Application for Licence Amendment

Licence Number	L8422/2010/2
Licence Holder	Edna May Operations Pty Ltd
ACN	136 365 001
File Number	DER2017/000298-1
Premises	Edna May Gold Project Warrachuppin Road WESTONIA WA 6423 Mining tenements: M77/88, M77/110, M77/124, G77/122 and L77/18 As defined by the Premises maps attached to the Revised Licence
Date of Report	4 November 2020
Decision	Revised licence granted

Figure 3: Bioremediation Facility

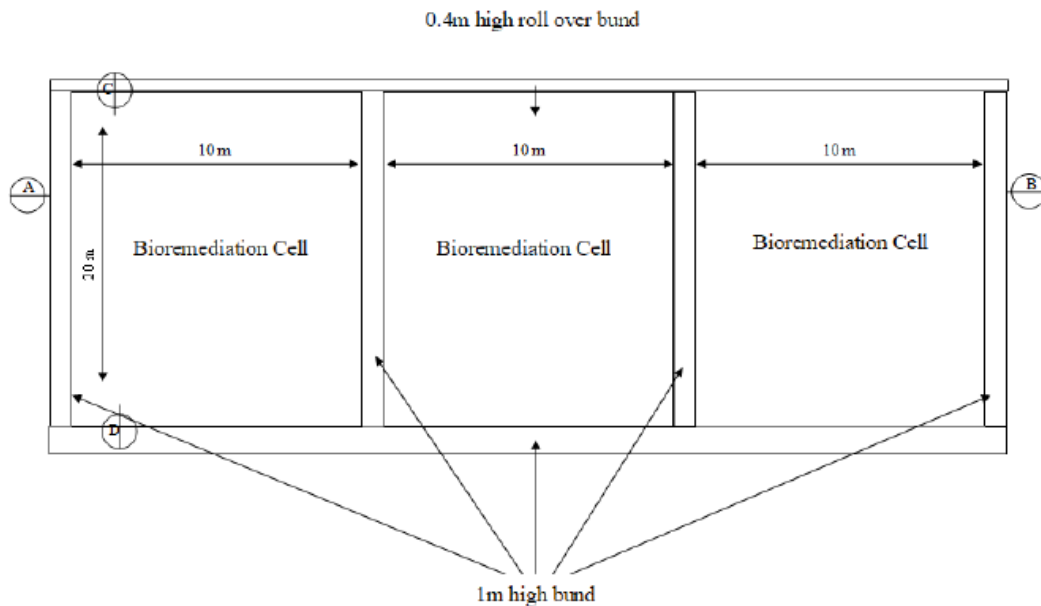
The applicant has confirmed that the new bioremediation area will be designed and constructed in accordance with the department’s contaminated sites guideline: *Assessment and management of contaminated sites, December 2014*. This means that it will be located:

- on a flat level ground;
- within a bunded area (1m height x 1m width), constructed with compacted in-situ clay material to a permeability of $1 \times 10^{-8} \text{m/s}$ to 10^{-9}m/s , with unauthorised access prevented by a locked access gate;
- groundwater within Westonia is between 28-40 mbgl and the bioremediation pad is on top of a 10m layer of mine waste (10m above natural surface level); and
- away from sensitive receptors and environmental receptors (closest residences are 900m east and 1.7km south)
